AGENDA

ARCHITECTURAL REVIEW BOARD MEETING

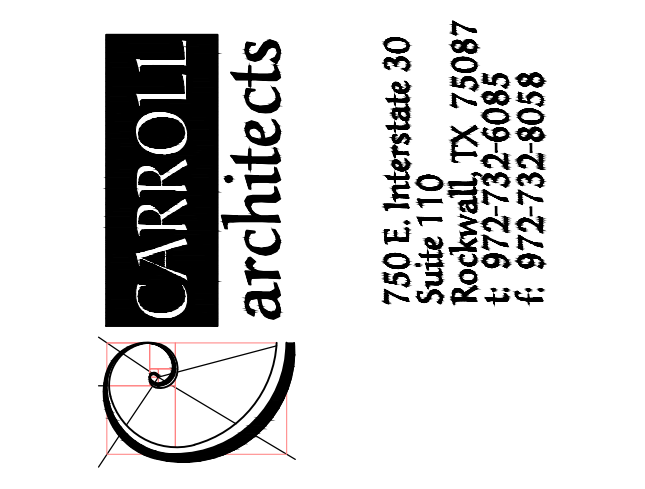
OWNER REVIEW: 04-23-2024
 CITY COMMENTS:
